UNITED STATES
NUCLEAR REGULATORY COMMISSION
WASHINGTON, D. C. 20555

March 8, 1983

SUBJECT: SUMMARY OF MEETING WITH BABCOCK & WILCOX (B&W) REGULATORY
RESPONSE GROUP CONCERNING SMALL BREAK LOCA PROCEDURES AND
MAINTAINING PROPER STEAM GENERATOR WATER LEVEL ON
FEBRUARY 23, 1983

FIGURE 4-12 REACTOR COOLANT SYSTEM ARRANGEMENT
 FOR THREE MILE ISLAND UNIT 2
 (SELECTED ELEVATIONS)

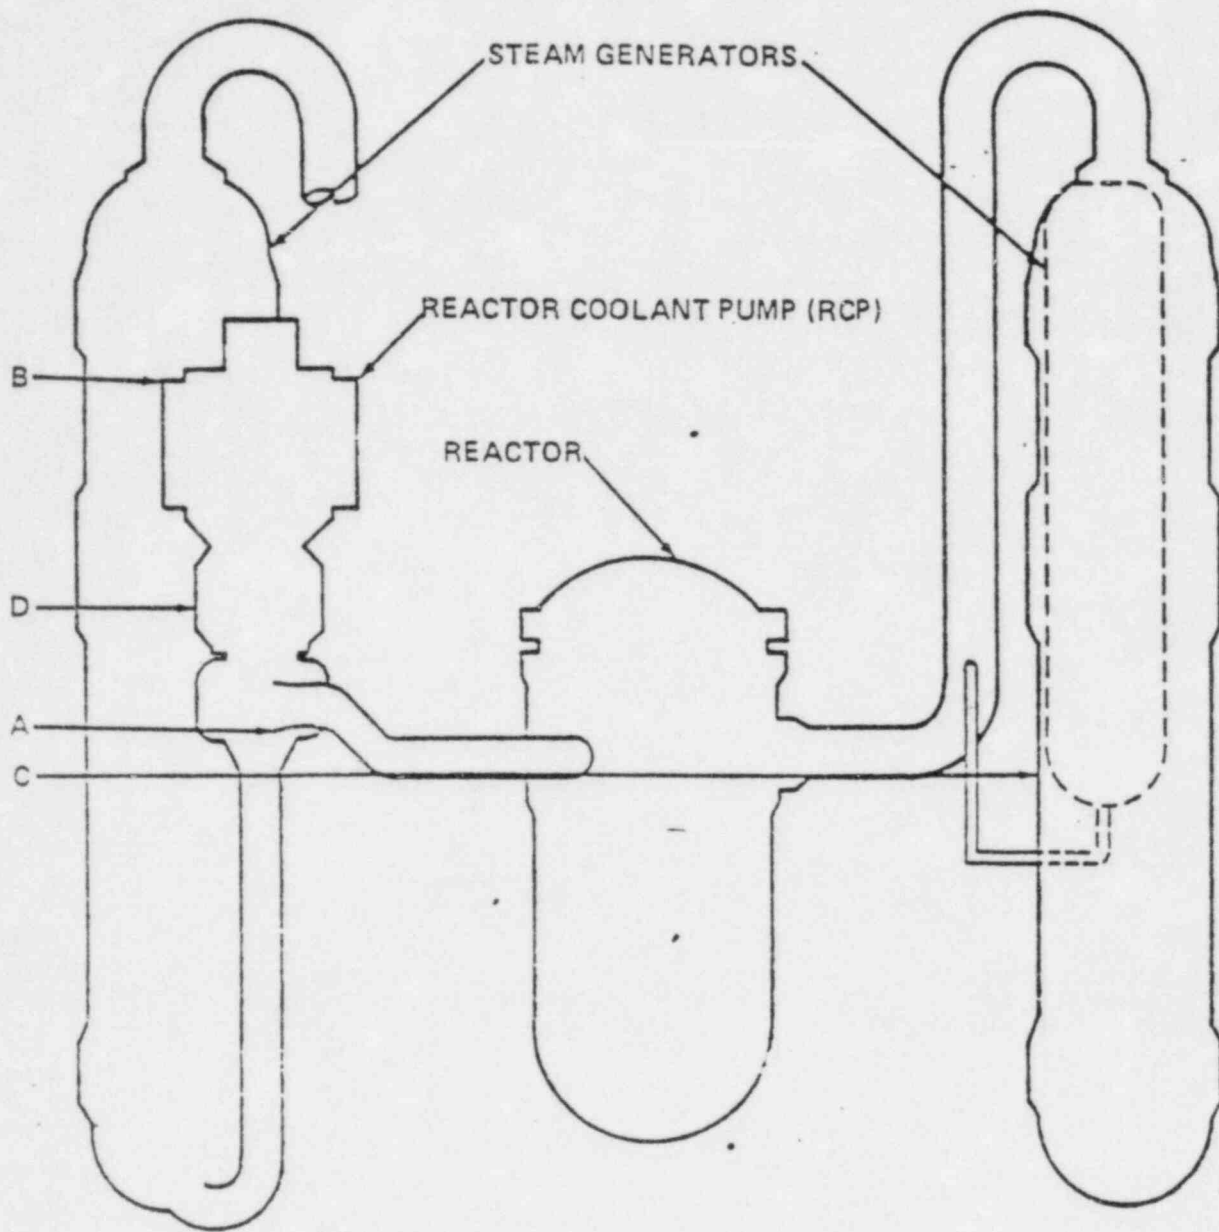
When the RCPs were tripped, the steam and liquid phases separated, with the liquid falling to the lower elevations of the primary system. For the TMI-2 plant, this is the bottom of the steam generators, the RCP suction piping, and the bottom of the reactor vessel, as can be seen on Figure 4-12. Also shown on Figure 4-12 is the elevation (elevation C) of the automatic feedwater control level setpoint, which was set to control level at 50 percent of the operating range when the RCPs were tripped. Since the TMI-2 accident, B&W has recommended that this level setpoint be increased to 95 percent of the operating range whenever the RCPs are tripped.

(elevation A in Figure 4-12). Feedwater enters the steam generators through a sparger at elevation B (see Figure 4-12), and would normally produce a condensing surface well above that needed to force the water in the RCP suction piping up through the RCP and into the discharge piping; however, feedwater will only be supplied if it is replenishing liquid lost through boiling. Without the initial flow of liquid out of the steam generators and into the reactor vessel, the stagnant primary coolant in the lower portion of the steam generator tubes will eventually reach equilibrium with the secondary water which will be held at the 50 percent level on the operating range (elevation C in Figure 4-12). When the heat transfer stopped, so did the boiling of the secondary water. This, in turn, stopped the feedwater demand, and the condensing surface due to sparger spray above the RCP discharge nozzle was lost. The only condensing surface left was the secondary water level, and it was below the elevation necessary to allow water to flow through the RCP and into the reactor vessel. Thus, liquid could not flow from the steam generators to the vessel, and the steam produced in the core could not condense in the steam generators.

Subsequent to the accident at TMI-2, B&W has included in its operating guidelines for small breaks the requirement for the operators at the lowered loop plants to manually raise the steam generator secondary water level to 95 percent on the operating range in the event that the RCPs are tripped. This is shown as elevation D in Figure 4.12.

This level assures that a steam condensing surface will exist at elevations above the bottom of the RCP discharge nozzle. Therefore, a sufficient static head of water will be available to establish natural circulation flow.
